**DEPARTMENT OF PUBLIC WORKS**

**STANDARD DRAWINGS**

**Published February, 2016**

ADDENDUM NO. 1  
TO  
CITY OF FRESNO 2010 STANDARD DRAWINGS  
ADOPTED MARCH 4, 1970  
RESOLUTION NO. 70-36  
UPDATED VERSION APPROVED AUGUST 2010

**CITY OF FRESNO**  
**S-5B**

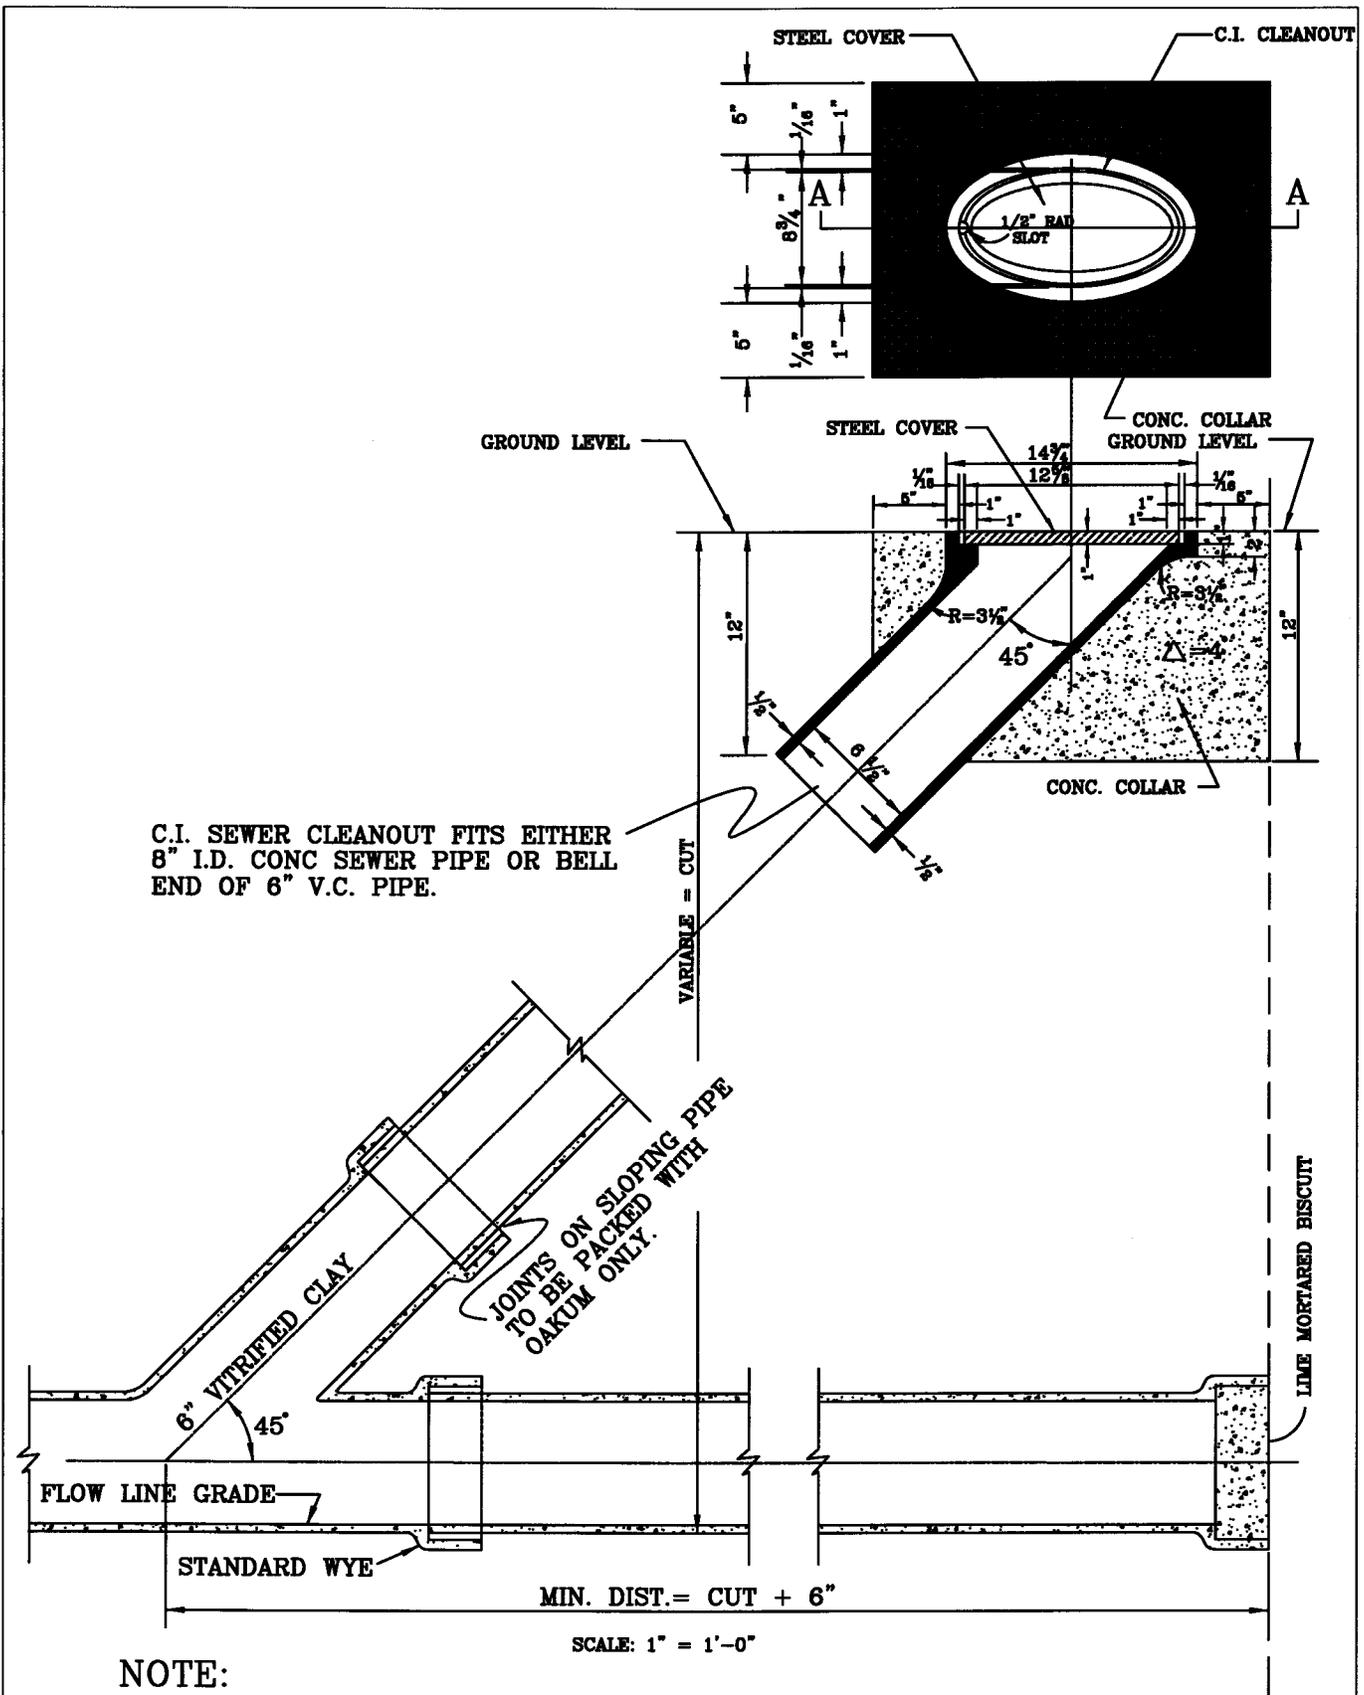
- S-5A Replaced Drawing "S-5" with "S-5A".  
Replaced frame weight "191 lbs" with "180 lbs".  
Scale 1"=1'-0" was deleted
- S-5B Added drawing S-5B "Pamrex Ductile Iron Frame and Cover for Sewer Pipe 27" or Larger".

- S-5B** Added Note 8 regarding placement of manhole cover opening.
- S-7** Replace "S-7" with "S-7A and S-7B"
- S-8** Changed house branch Tee Fitting material to SDR35 to match uniform plumbing code  
Changed compression fitting to Gasket PVC Hub  
Added "Total gap not to exceed 1/2'" note to ensure proper connection is made.
- S-9** Clarified Note 4 regarding maximum extension of the saddle into the sewer main.
- S-10** Replace "Ref. Std. Dwg. P-40" with "Ref. Std. Dwg. P-48"
- S-11A** Added note to "Min. Model Height" to address heights less than minimum.
- S-12** Correction to Note 2.

CITY OF FRESNO  
E-27

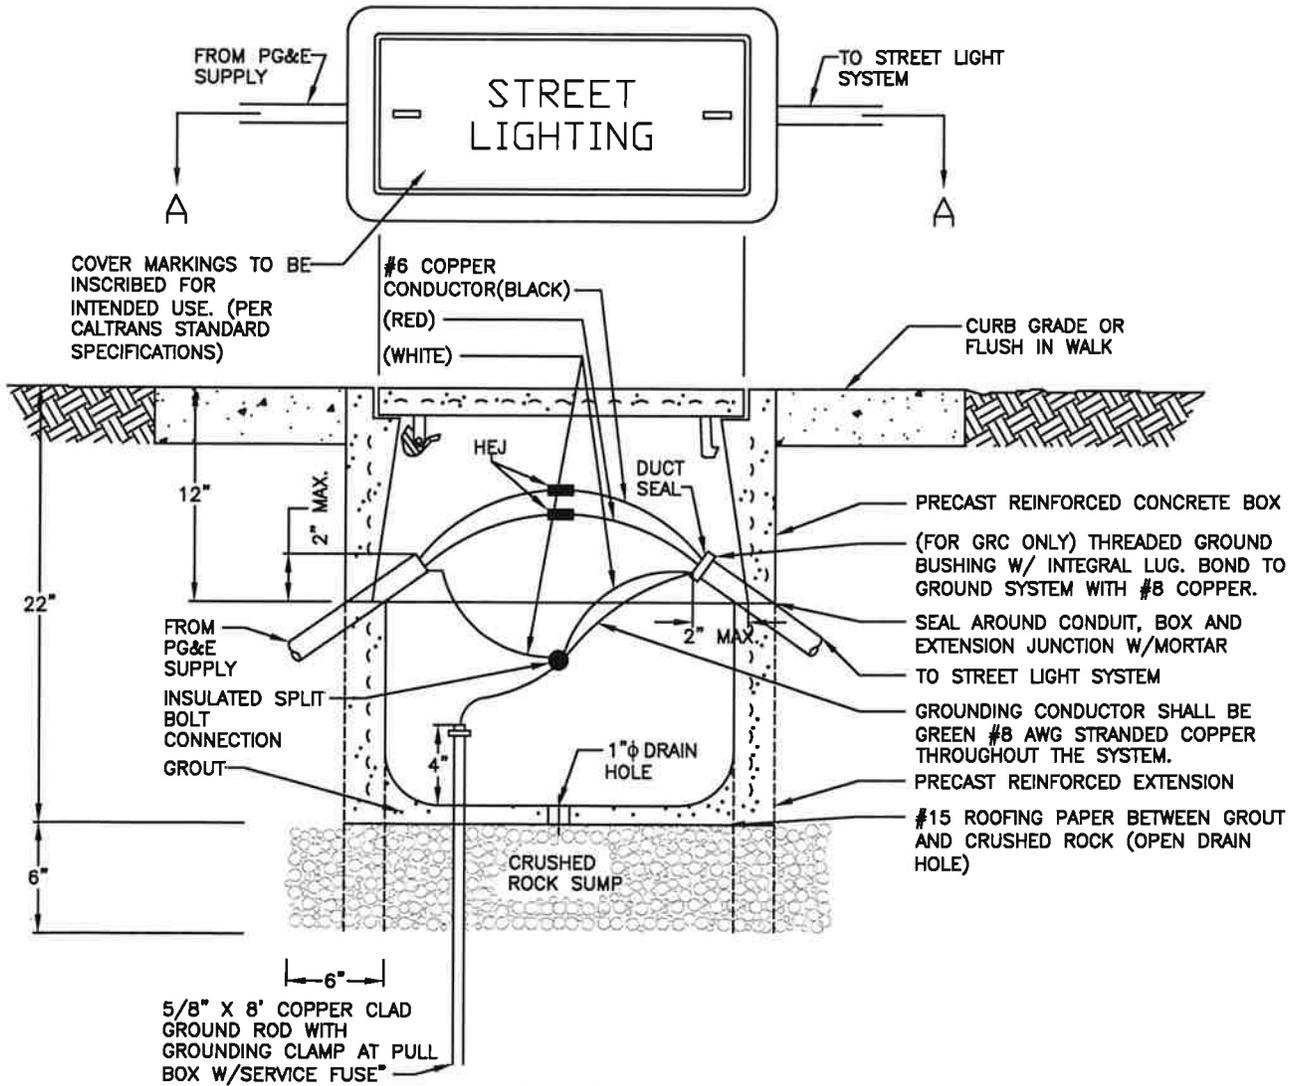
- E-26 Updated part numbers.
- E-27 Modified conduit drawing for clarity.
- E-28 Deleted, replaced with E-4C.
- E-34A Corrected text errors in "Caution" note, changed "752" discriminator to "762".

CITY OF FRESNO  
E-37

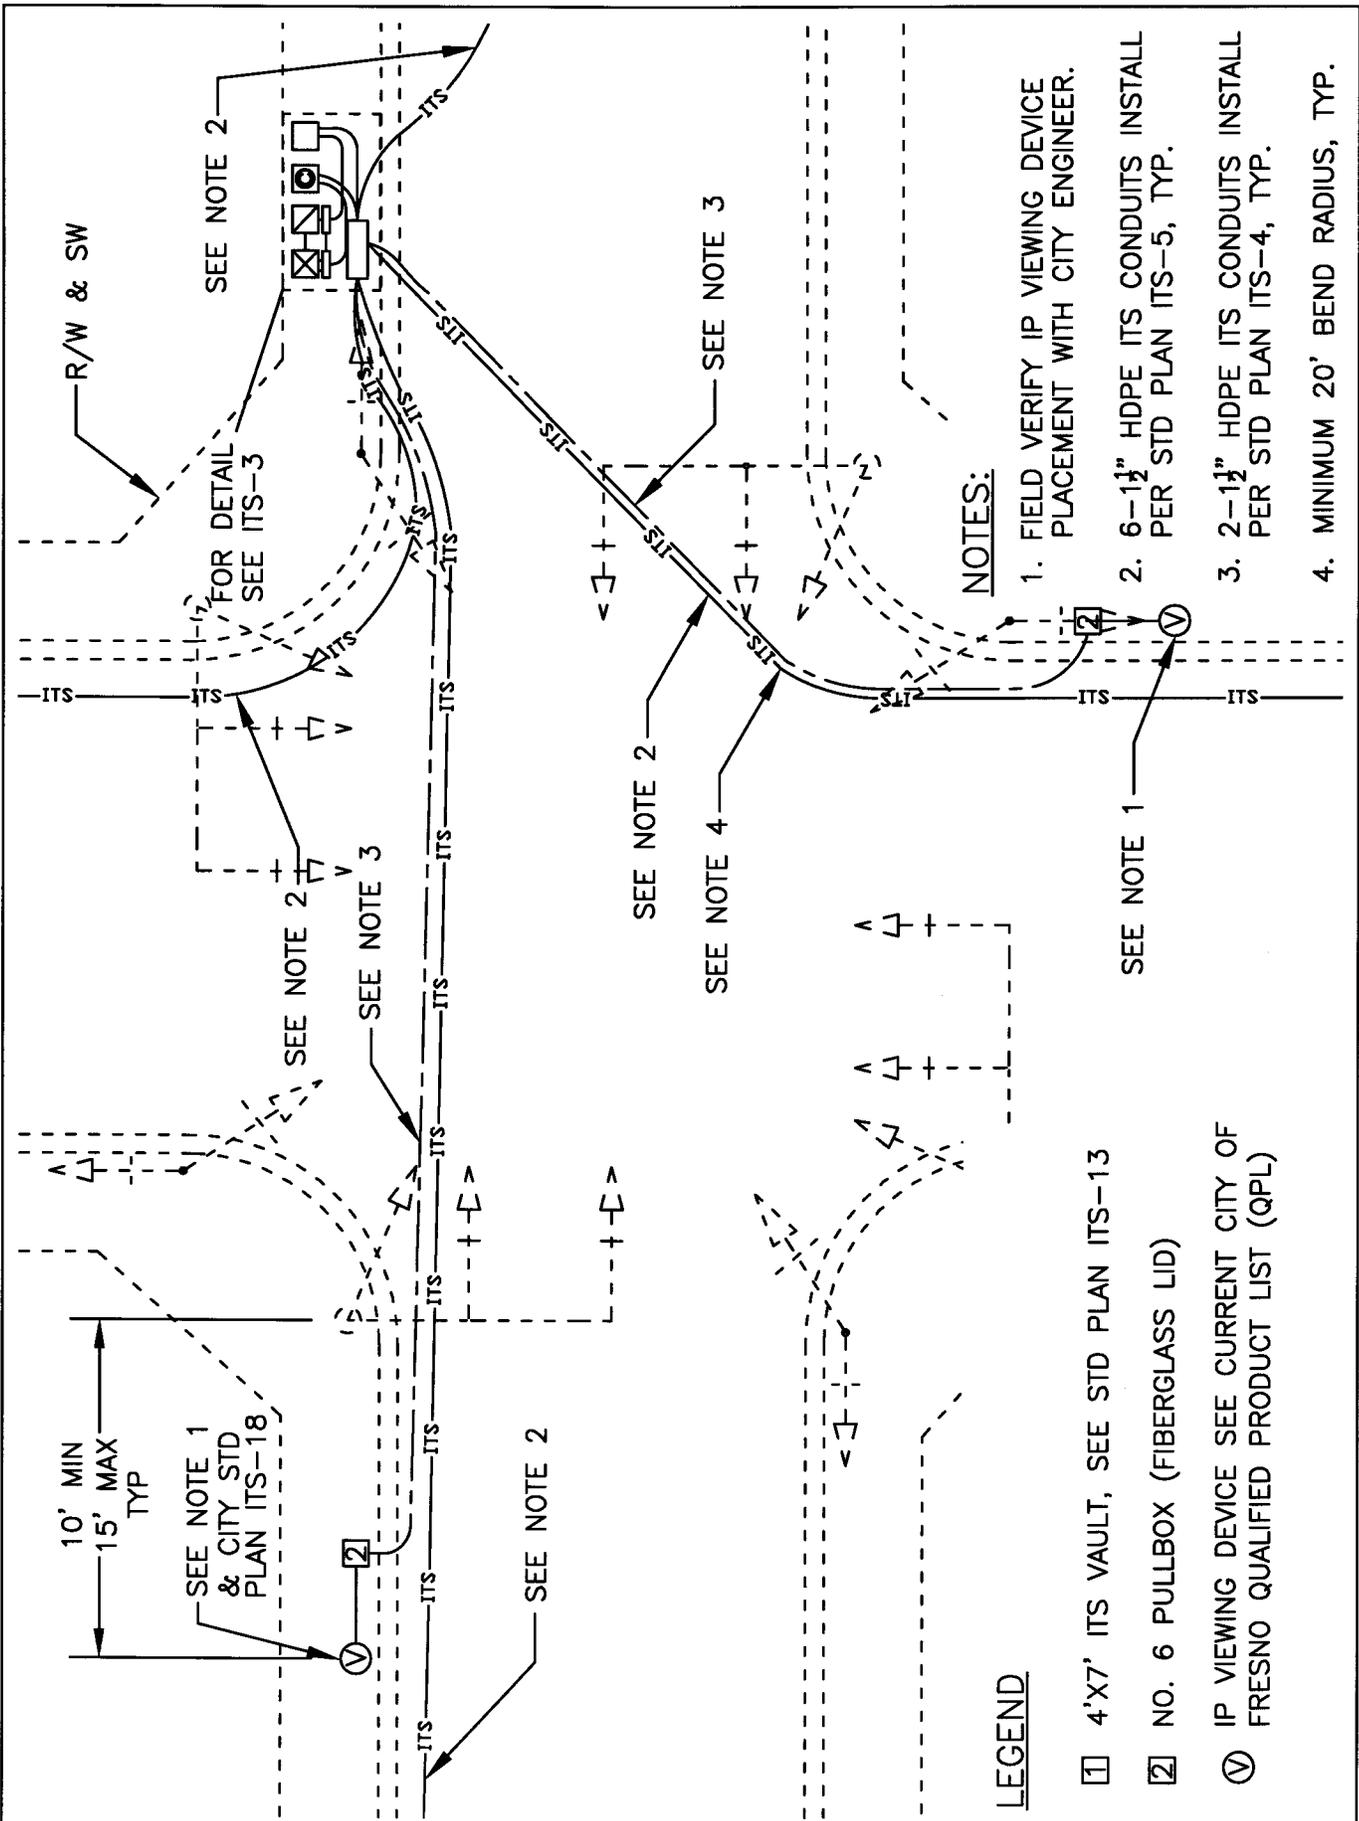
- Paragraph 11: added "as shown in Dwg. E-37"
- 23-1.9 Paragraph 2: Clarified use of PVC conduit.
- Paragraph 6: Clarified bonding bushings shall have integral lay-in lugs
